# Building Code of Australia 2019

Report for BCA Compliance

PROJECT NAME: New Western Sydney University Bankstown City Campus

DATE: 29<sup>th</sup> July 2019

### Clause E1.8/Specification E1.8 – Fire Control Centres

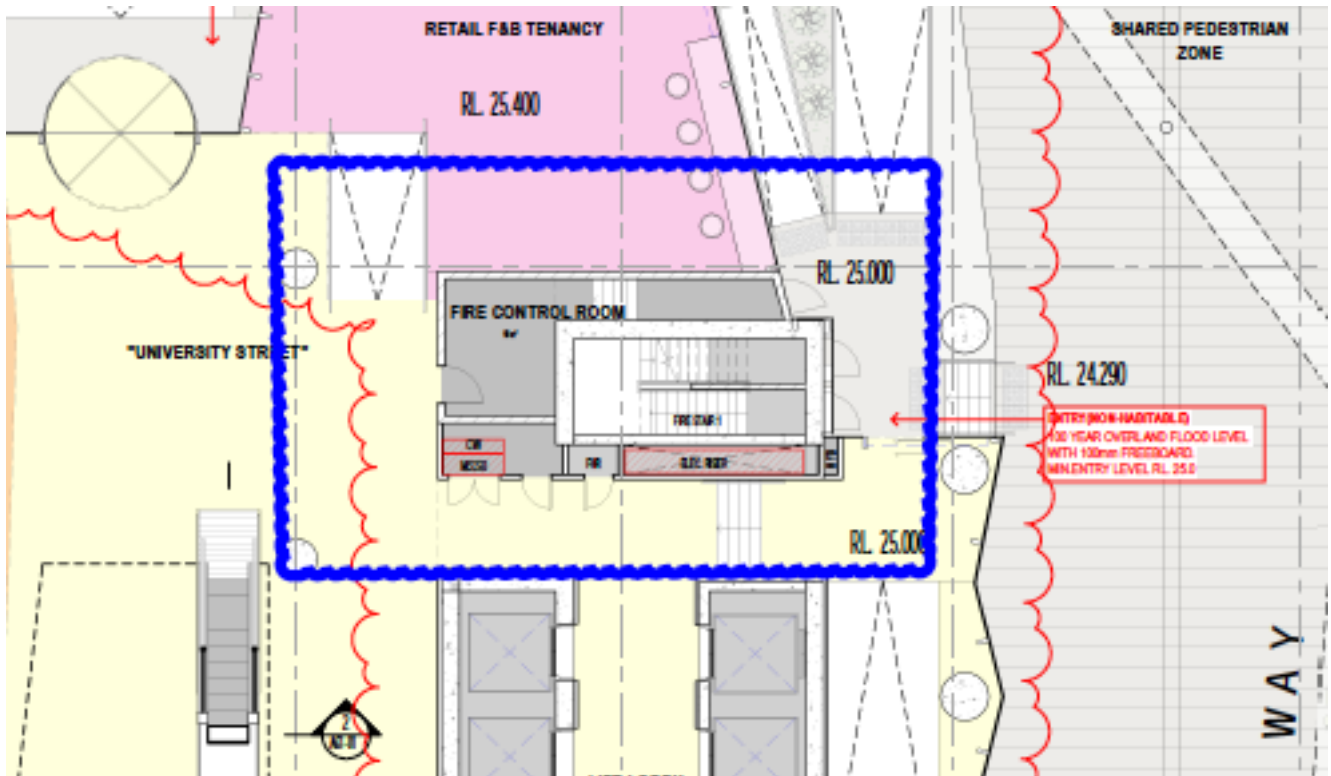
Specification E1.8 requires a Fire Control Centre be located within a separate room (Fire Control Room) where the effective height of a building exceeds 50m. Specification E1.8 (3) states that a fire control centre must not be so located in a building that egress from any part of its floor, to a road or open space, does not involve changes in level which in aggregate exceed 300mm.

The proposed location of the fire control room is in aggregate approximately 700mm above the level of the closest area considered a road or open space. A Performance Solution is to be developed to address this non-compliance.

#### **Smoke Exhaust Rate**

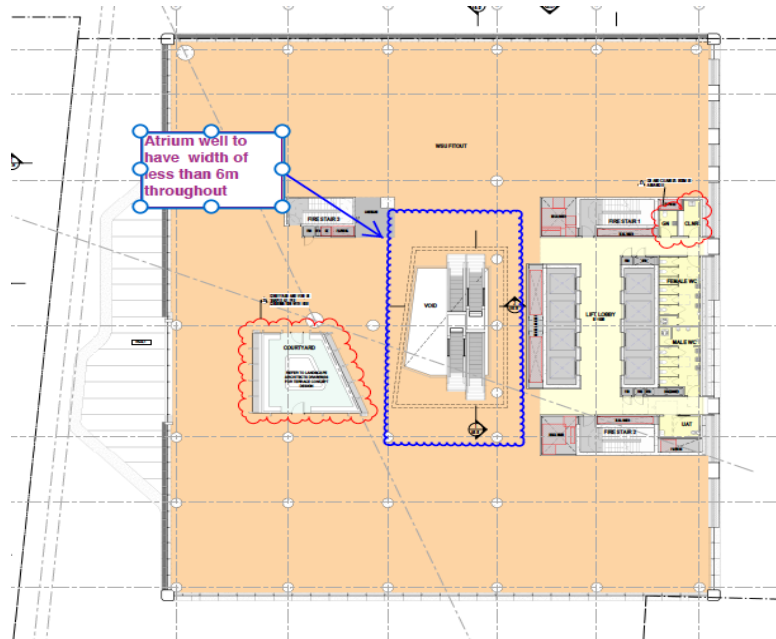
The smoke exhaust rate for the smoke exhaust system required for the atrium is designed exclusively for Class 9b use however the atrium fire compartment has Class 6 areas opening into it as well. The exhaust rate is proposed to be 45m<sup>3</sup>/s in lieu of 74m<sup>3</sup>/s. This non-compliance will be addressed via a performance solution by the Fire Engineer.
